**September 2006 Errata to
Final Environmental Impact Report
September Ranch Subdivision Project
Monterey County, California**

Section 1 - September 2006 Errata to Final EIR 1-1
 1.1 Revisions to the Final Environmental Impact Report (July 2006) 1-1

**Appendix A:
Responses to California Department of Fish and Game
March 30, 2006 Letter (CDFG)**

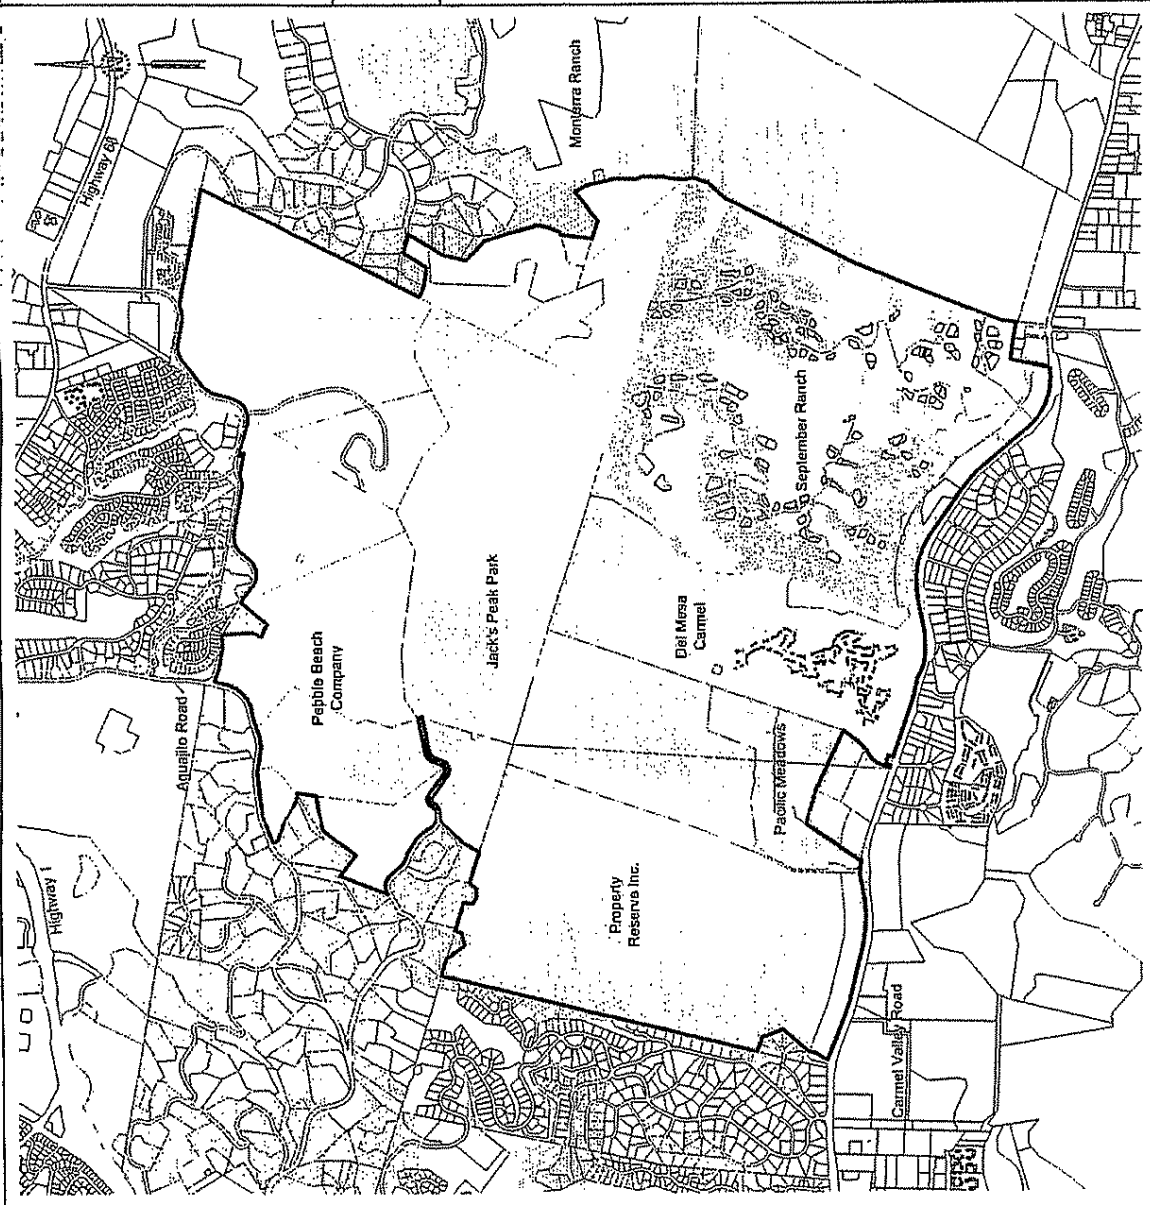
A cumulative impact assessment study area was defined based on the occurrence of large remaining blocks of intact Monterey pine forest contiguous with the ridges adjacent to Jack's Peak Regional Park and the project site (see Figure). Monterey pine forest habitat in this area occurs primarily on inland Monterey shales with coast live oaks often forming a subcanopy and typical understory associates including grasses and mixed shrubs such as poison oak, bush monkeyflower, California blackberry, coyote brush and California coffeeberry. Notable differences between this habitat type and Monterey pine forest on different soils at lower elevations on the Monterey Peninsula have been identified (Jones and Stokes Associates, 1994). Therefore, it is appropriate to consider cumulative impacts to this habitat type on a sub-regional basis.

Seven contiguous and relatively large ownerships covering an area of approximately 3,758 acres define the study area (see Table and Figure). While other, mostly smaller land holdings with this type of Monterey pine forest habitat occur in the vicinity outside of this study area, those parcels are primarily developed as single family residential parcels; in most cases, their ultimate disposition relative to open space dedication and land use restrictions has long been established and does not materially affect this cumulative impact assessment.

On the seven ownerships, Monterey pine forest occurs on approximately 3042.5 acres or on over 80% of the land area within the study area. Previously dedicated or otherwise set aside and undeveloped open space primarily supporting Monterey pine forest occurs on three of the seven ownerships (Del Mesa Carmel, Pacific Meadows and Monterra Ranch) adjoining Jack's Peak Regional Park and totaling about 460.5 acres. A minimum of 266 acres of the 796.3 forested acres on Pebble Beach Company holdings at Aguajito have been committed to open space as part of the recent approval of the Del Monte Forest Preservation and Development Plan. When added to the 826 acres of Monterey pine forest within public open space at Jack's Peak Regional Park, the existing and proposed dedicated acreage totals about 1,552.5 acres or over 50% of the Monterey pine forest habitat in the study area.

Development of roads, infrastructure and houses on September Ranch would directly affect about 34.9 acres of the existing 426 acres of Monterey pine/coast live oak forest on the property. The remainder of the forested land (over 390 acres) would remain relatively undisturbed as either common or private open space. A significant portion of the forested land on September Ranch contiguous to Jack's Peak would be dedicated through conservation easement or other appropriate means to increase the habitat preserve "footprint" adjacent to the regional park.

September Ranch's contribution to direct loss of Monterey Pine forest, approximately 34.9 acres, represents slightly greater than a 1% incremental loss to Monterey pine forest habitat in the cumulative impact assessment study area.

There are no reasonably foreseeable probable future projects within this study area. There are two parcels in the study area contain Monterey pine forest and have some development potential: the remaining 530.3 forested acres on Pebble Beach Company holdings at Aguajito & the 533.3 forested acres on lands of Property Reserve, Inc. However, no applications to develop these parcels have been submitted and there are no proposals for development of these properties. Slope constraints substantially limit the development potential of both sites. In addition, the PRI parcel is under a Williamson Act contract which limits its use to agriculture for the duration of the contract period.

Land use restrictions and dedication of up to 390 acres of Monterey pine forest on September Ranch could increase the area of forested open space within the study area from 1552.5 acres to 1942.5 acres, which represents as much as a 25% increase in base acreage of designated undevelopable forest. This additional acreage will help ensure the long-term sustainability and manageability of the Monterey pine resource by expanding the contiguous block of intact forest preserve along the flanks of Jacks Peak Regional Park. The level of cumulative loss due to the project, especially with open space dedication and/or land use restrictions on the remaining forested acres, is minor because a significant contiguous block of Monterey pine forest habitat will remain in place that is sufficiently large to sustain this habitat. In fact, the cumulative loss of Monterey pine forest habitat would not be substantial even assuming both the Pebble Beach Company and Property Reserve, Inc. were developed at a similar level of density as the September Ranch project.

Comment noted. Although not specifically referenced in the REIR, this information was independently reviewed by the project consultants in reaching impact conclusions.
